Re: Re: 2013 Amended General Rate Application of Newfoundland and Labrador Hydro

Requests for Information by Innu Nation

IN-NLH-231 to IN-NLH-283

Requests for Information – Round 3

29 IN-NLH-245. **Re: IN-NLH-030 and IN-NLH-030, Rev. 1**

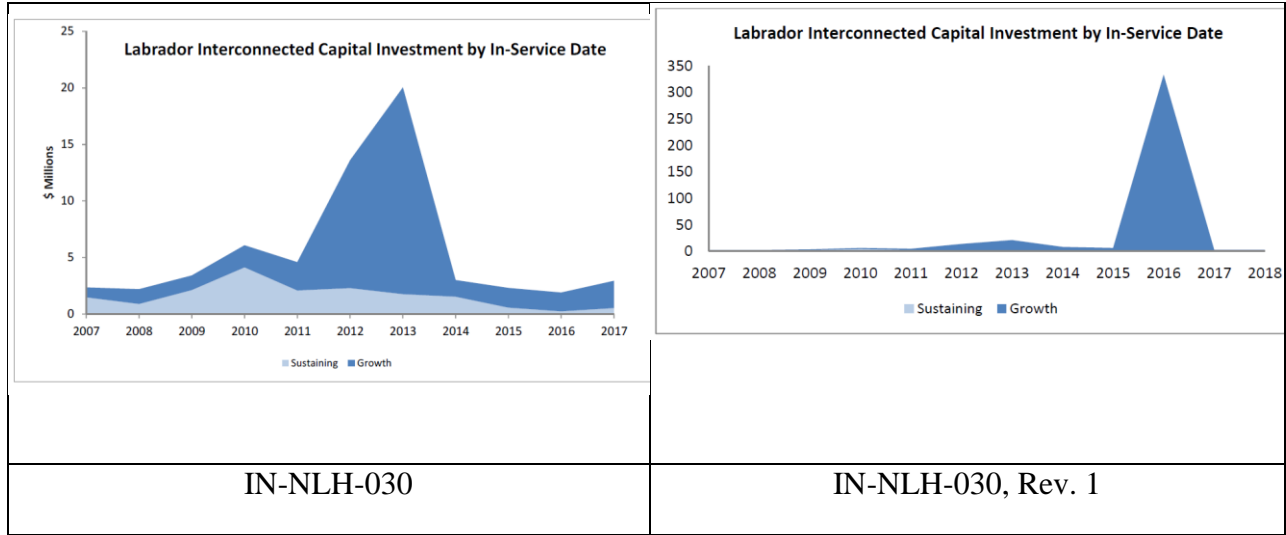
1 The graphs for Capital Investment as shown in IN-NLH-030 and in IN-NLH-030, Rev. 1
2 are reproduced below:

- 5
- 6 • if the Sustaining investments shown in the original graph are shown in the revised graph;
 - 7 • if the Growth investments of approximately \$15 and \$20 million shown in the original graph for 2012 and 2013, respectively, remain unchanged in the revised graph.

8 Please identify the investments of approximately \$350 million forecast for 2016 shown in the
9 revised graph, and explain why they were not shown in the original graph.

10 Please present the figures represented in both the original and revised versions of this graph in
11 tabular form.
